DATE: November 13, 2009

Addenda No. 1

SUBJECT: OR213: Cascade Hwy S (Milk Cr Br) Mulino Section
Cascade Highway
Clackamas County
Grading, Drainage, Structures, Paving and Signing Project
(Bids to be opened and read November 19, 2009)

SHEET NO.
GH

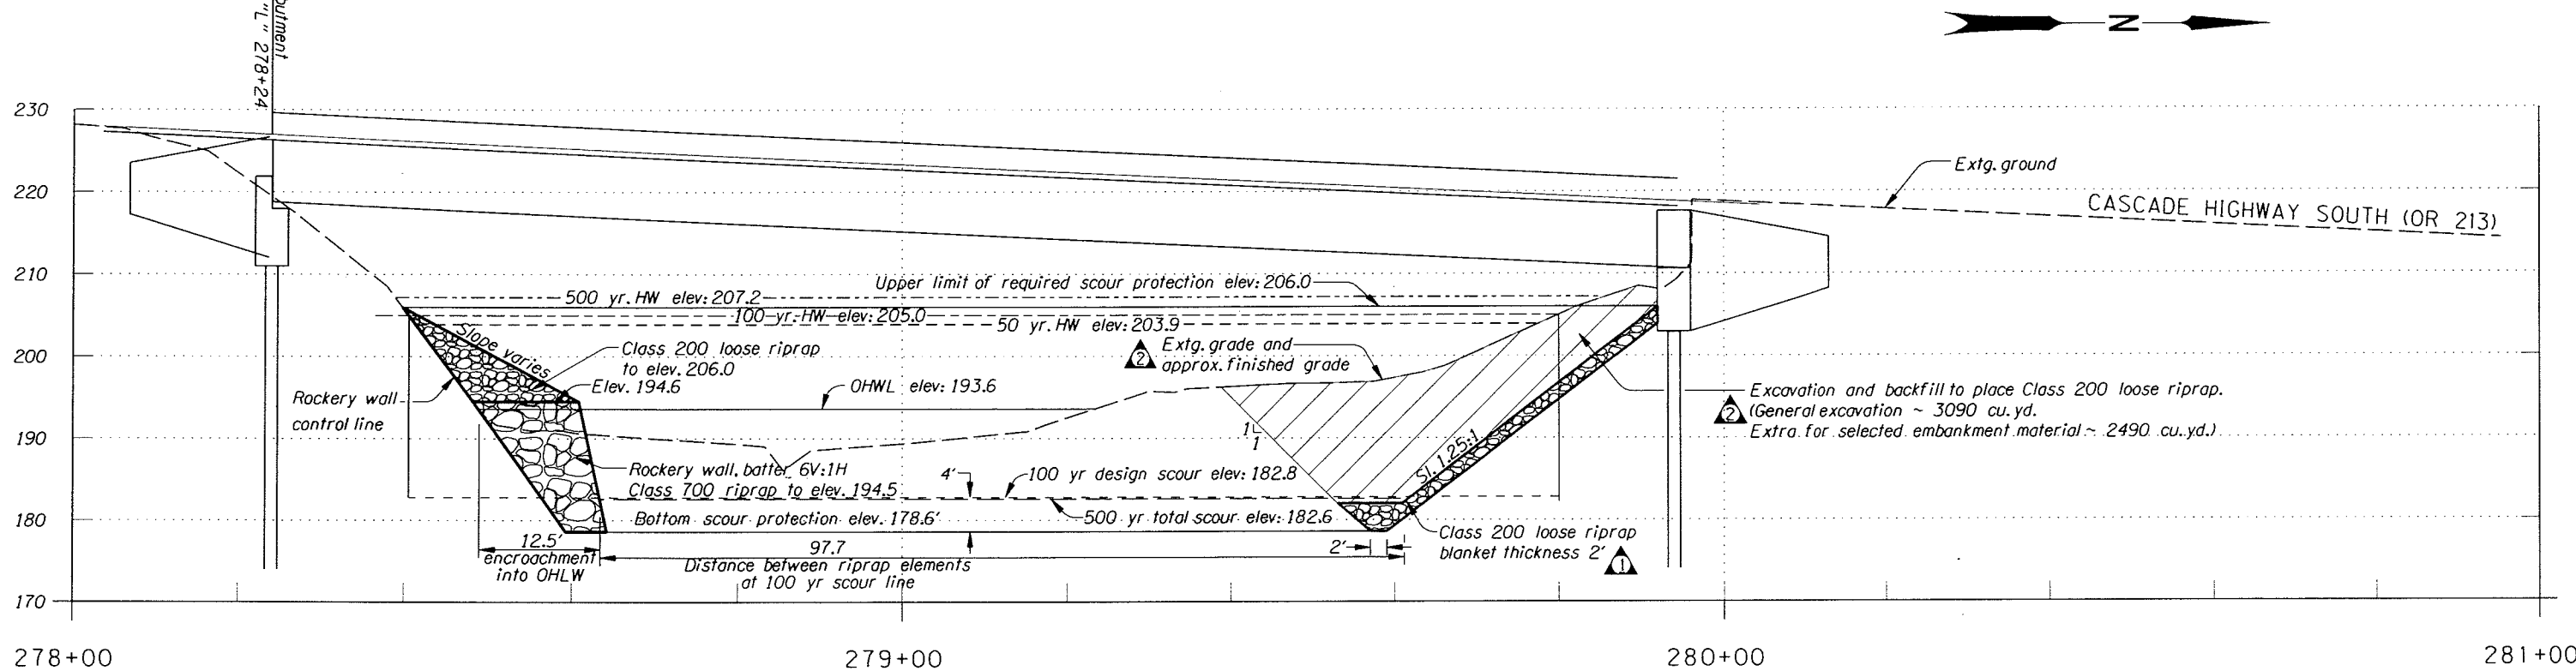
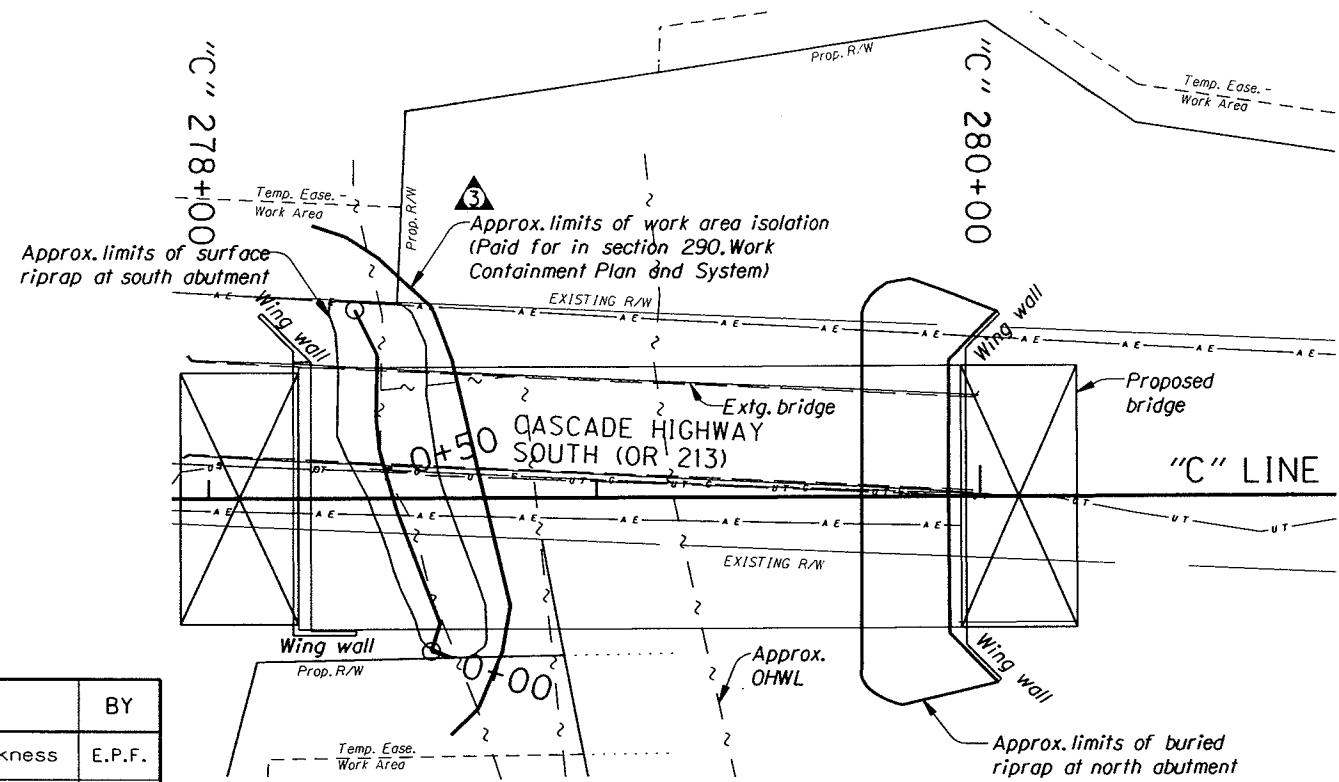
No.	DATE	REVISIONS	BY
①	11-06-09	Modified note for proper thickness	E.P.F.
②	11-06-09	Added notes	E.P.F.
③	11-12-09	Added note for riprap work isolation	E.P.F.
